City of NAPOLEON, OHIO

Re: Permits No. 01332, 01345 &
01375.

RESIDENTIAL PLAN CORRECTION SHEET

PLAN CORRECTION SHEET

Lakeview Drive

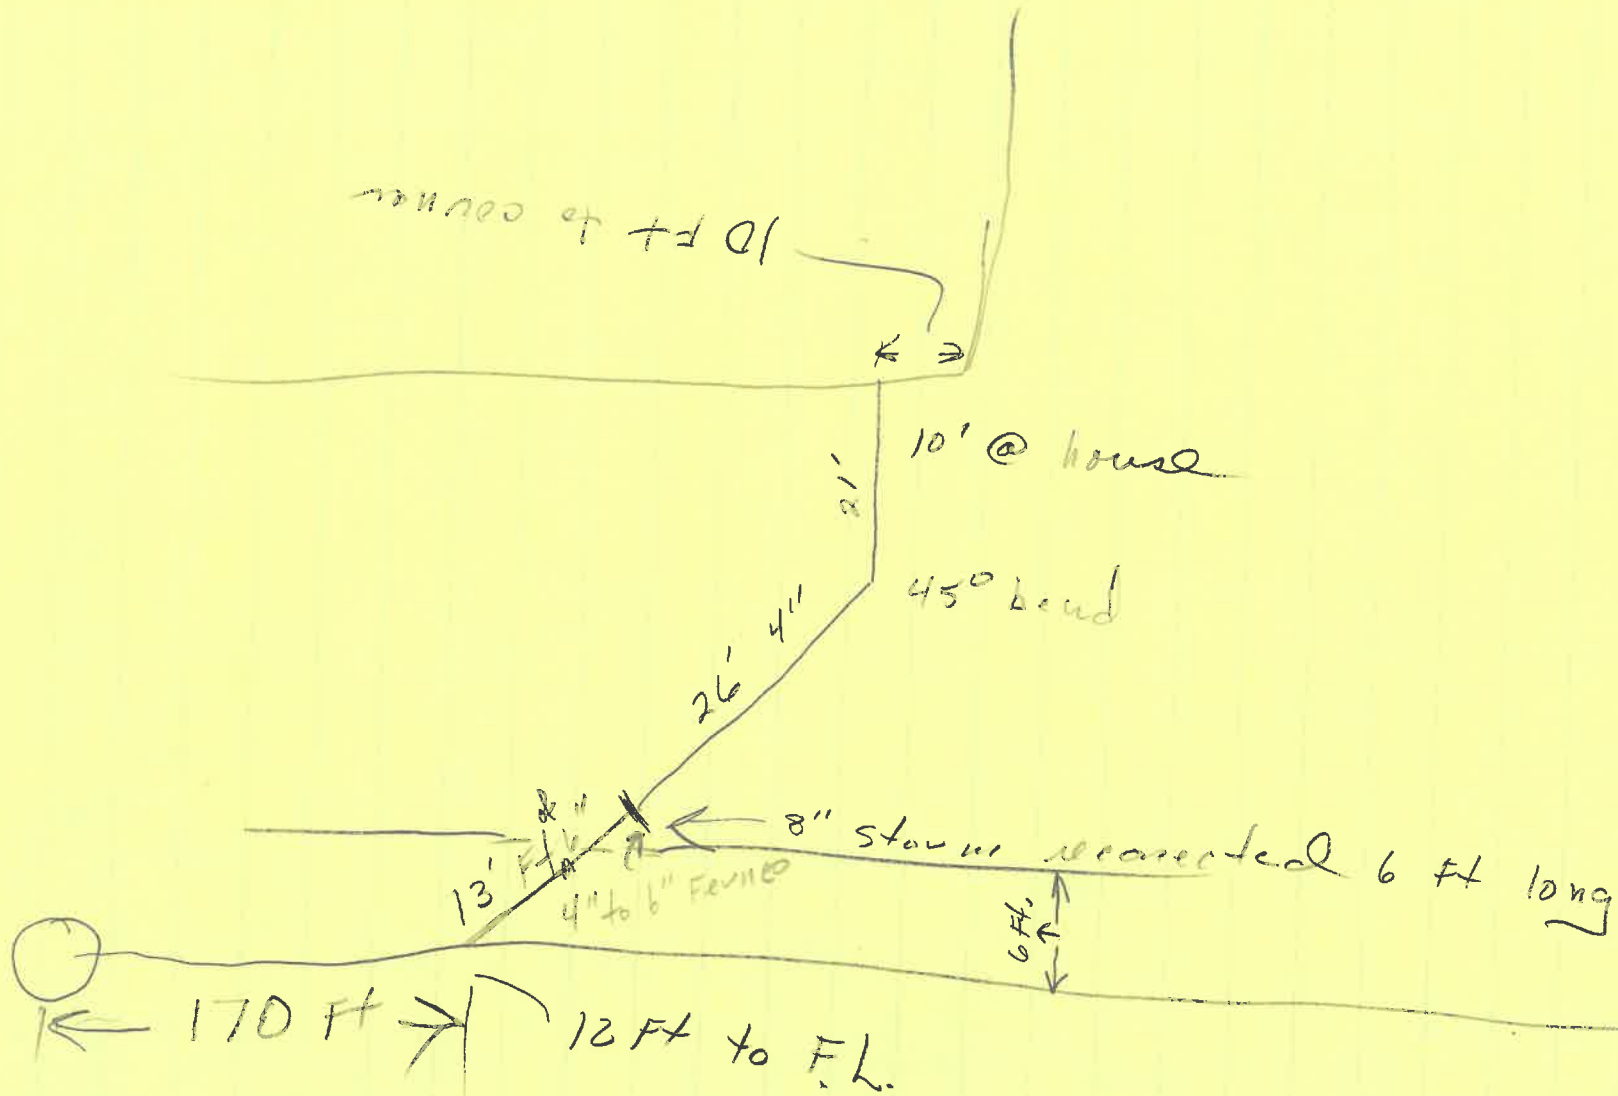
1- 3'-0" x 6'-8" EXIT DOOR IS READING
? IS THE FRONT DOOR TO DR A
DOUBLE DOOR R-211 & R-212

PROVIDE DESIGN INFO FOR STEEL
BEAM IN BASEMENT

? PROVIDE 3- 2X12 STRINGERS

THE LAUNDRY SINK AND WASHER
LOCATED IN THE BASEMENT MUST BE
DRAINED INTO THE SANITARY SEWER,

THE FOOTING DRAIN TILE MUST BE
DRAINED INTO THE STORM SEWER

TRUSSES & FLOOR BEAM OK
